## SUBDIVISION REVIEW SHEET

**CASE NO.:** C8-2023-0067.0A

**SUBDIVISION NAME:** Poss-Laitner Subdivision

CITY OF AUSTIN –DEVELOPMENT SERVICES DEPARTMENT  
SUBDIVISION APPLICATION – MASTER COMMENT REPORT

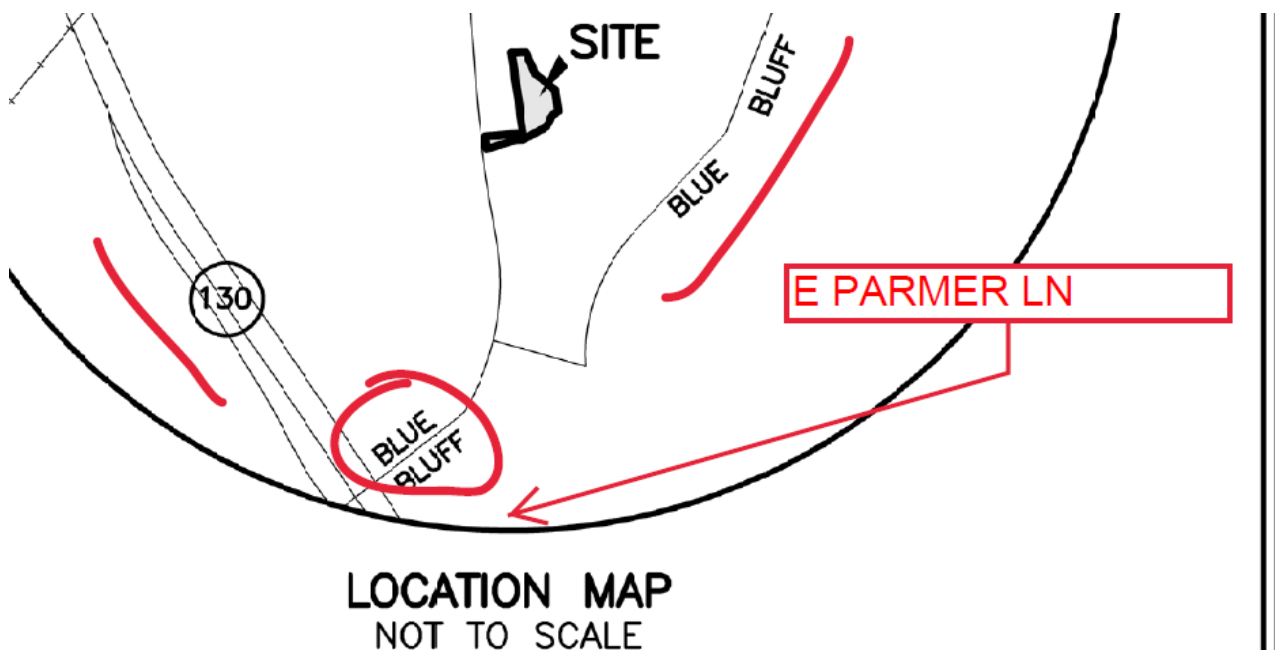
AD2: Please remove all street labels in the vicinity map **EXCEPT** the following:

- Please update label for **E PARMER LN** the street type LN must be included in the vicinity and exhibit
- Please update label for **BLUE BLUFF RD** the street type RD must be included
- Please update label for **E US 290 HWY** the directional E must be included
- Please update label for **N SH 130** the directional N must be included
- Please replace label **BLUE BLUFF** with E PARMER LN

NOTE: BLUE BLUFF is labeled incorrectly as E PARMER LN
